INDIANA HARBOR BELT RAILROAD COMPANY

BULLETIN ORDER NO. S-10
Effective: 0600 Sunday January 2, 2022

December 30, 2021
General Orders in effect: 101

16. Kankakee Line, Special Instructions – MODIFIED 9/14/2021

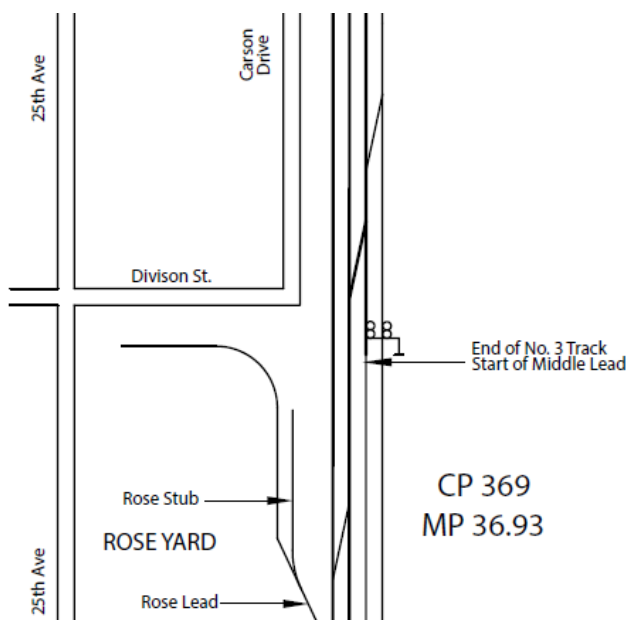
Effective 0600 9/14/2021, employees must make the following changes to the second bullet point under **SPECIAL INSTRUCTIONS** on page 7 of IHB Timetable No. 3. Strike through ~~CP GIBSON~~ and write in CP HOUSE. Foreign line crews must make the same changes to Page IHB-46 in the CORA guide. Below is how the second bullet point will read after the changes are made:

NO. 4 CONNECTING TRACK BETWEEN CP HOUSE AND CP 42: 10 MPH – RULE 6.28 IN EFFECT

23. DISPATCHER CHART – IHB MAIN LINE – REVISED 7/20/2021:

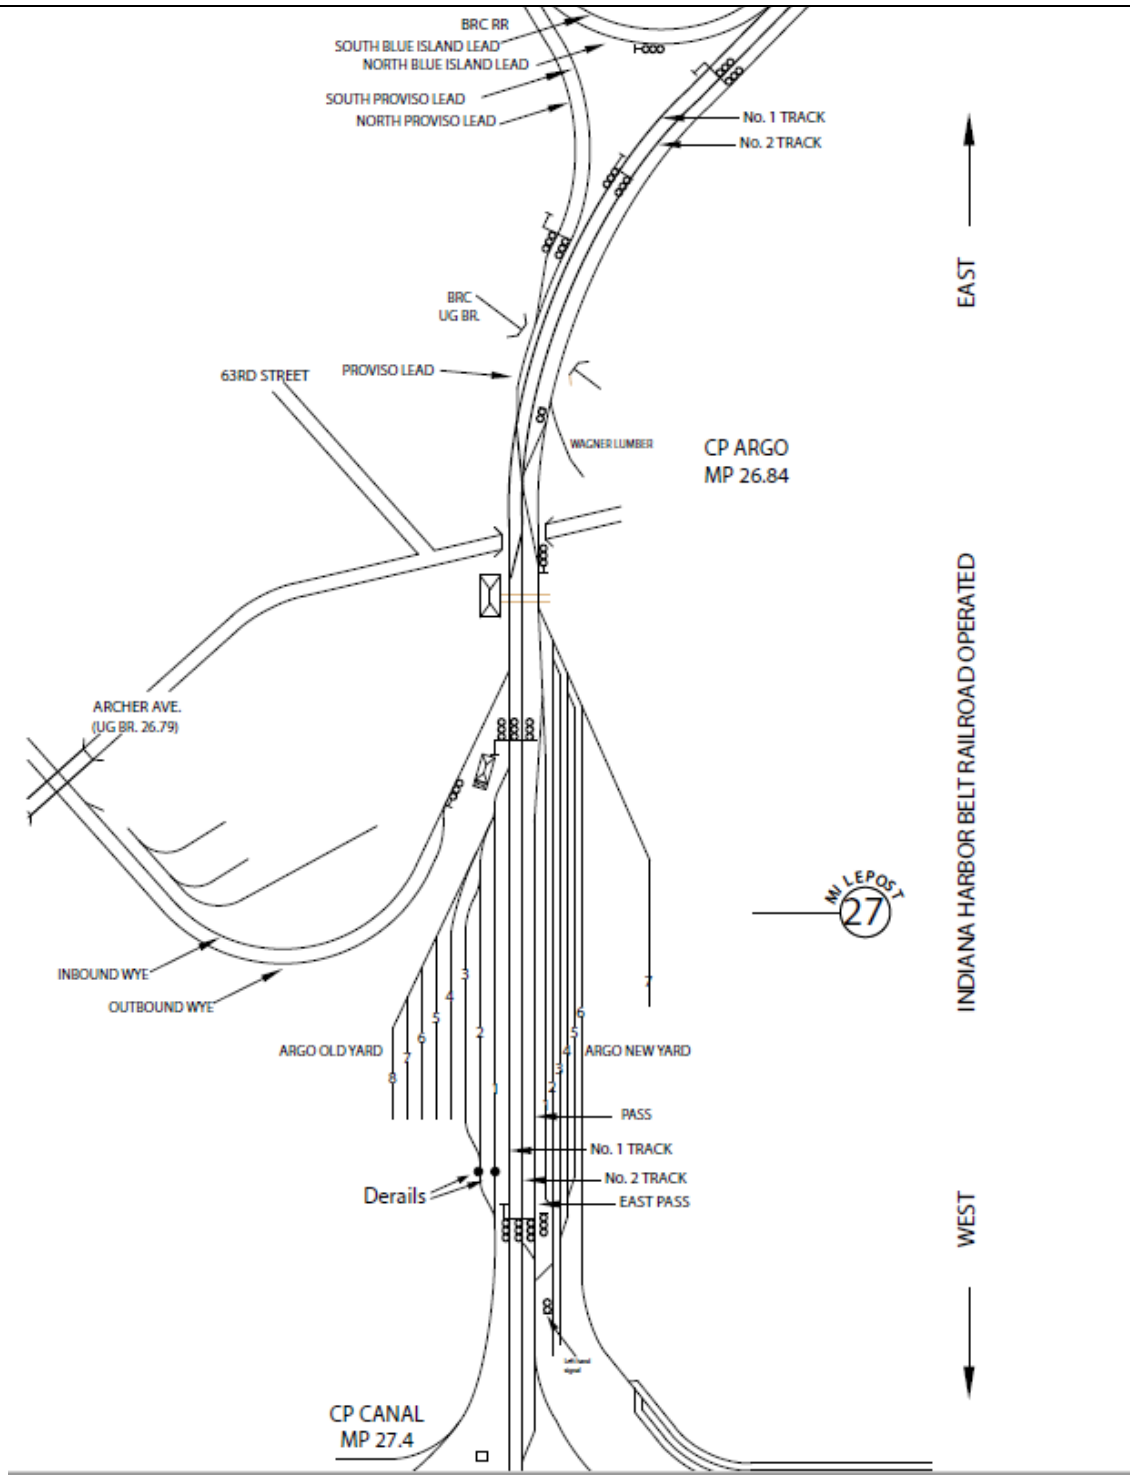
Effective 0600 7/20/2021, employees must make the following change to the Dispatcher Chart – IHB Main Line on page 16 of IHB Timetable No. 3. Foreign line crews must make the same change to page IHB-55 in the CORA Guide. Strike through ~~1,753~~ on the Dispatcher Chart – IHB Main line CP Argo to CP Canal on No.1 and No.2 main and write “1,113” in ink to revise the distance.

26. 2900 SIGNAL ASPECTS AND INDICATIONS – REVISED 7/16/2021:

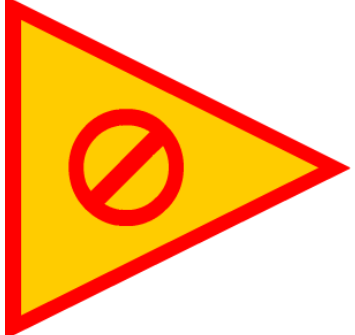
Effective 0600 7/16/2021, employees will be governed by image as shown below. Managers will use the Reflectorized Triangle to simulate an improperly lined switch or derail to monitor compliance with GCOR 6.27, GCOR 6.28, and GCOR 8.2. Managers will also use the Reflectorized Triangle to simulate a contaminated flange way to monitor compliance with GCOR 6.32.1 SI 2409. Employees must make a notation on page 114 of IHB Timetable No. 3 that the rule is changed in this notice. In the near future a sticker will be made available to make the modification to page 114. Foreign line crews make the same change to page IHB-42 in the CORA Guide.

<p>6.27 (a) 6.28 (a) 6.32.1 SI 2409 (a) 8.2 (a)</p>		<p>SWITCH POINT, DERAIL, AND CROSSING INSPECTION TEST</p>	<p>The flag below is used to test employee’s compliance with GCOR 6.27, GCOR 6.28, GCOR 8.2, and Timetable Special Instruction 2409.</p> <p>Employees observing this flag must not remove it. Contact a supervisor to discuss applicable rules.</p>
---	---	--	---

27. TERRITORIAL QUALIFICATIONS OF TRAIN SERVICE EMPLOYEES – REVISED 7/7/2021:

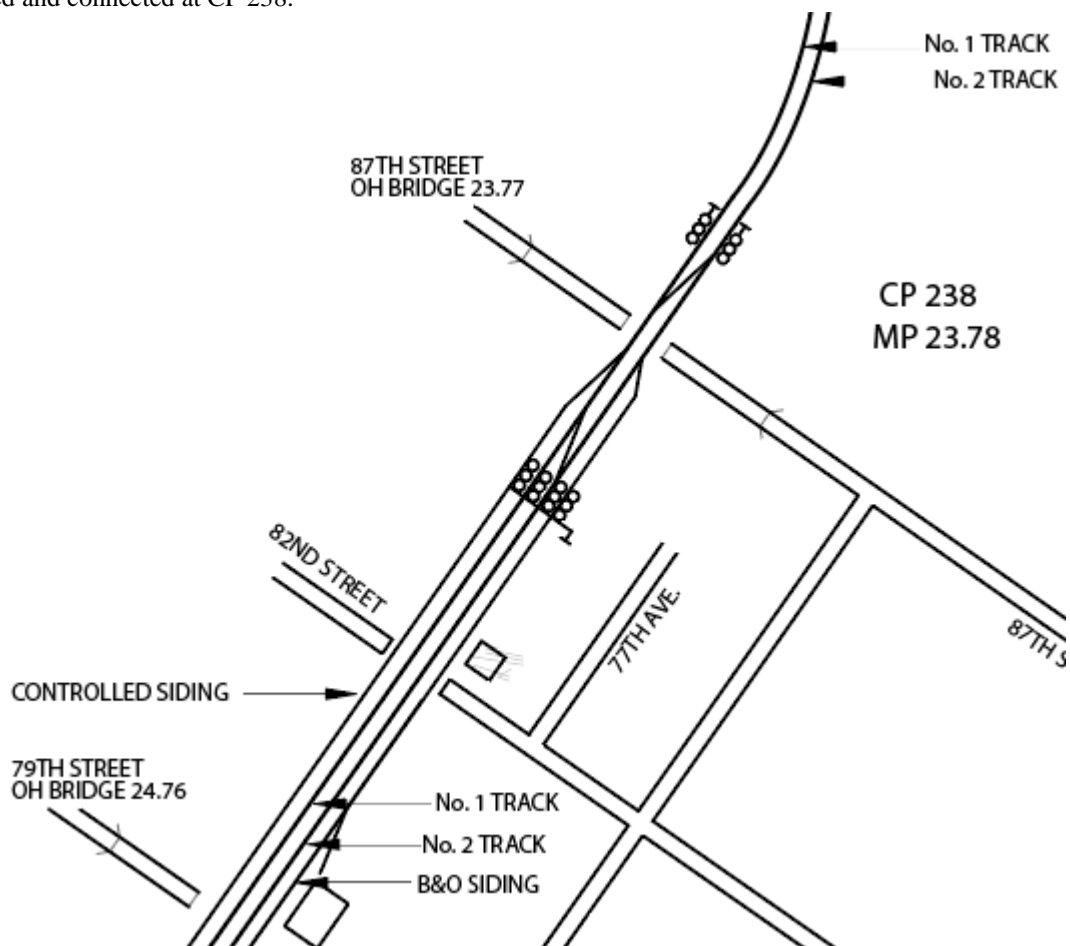
Effective 0600 7/7/2021, train service employees will be governed by the following. Locomotive Engineers qualifications for main track now will read “One Round Trip over the territory within the previous 24 months”. Train Service Employees must make changes below on page 2 of IHB Timetable NO. 3 and make a notation that the rule is changed in this notice. In the near future as sticker will be made available to make the modification to page 2.

- **Main Track** – One Round Trip over the territory within the previous **24** months.
- **Other Than Main Track** – Territorial familiarization briefing with qualified supervisor or engineer will be provided with an up-to-date job aid.
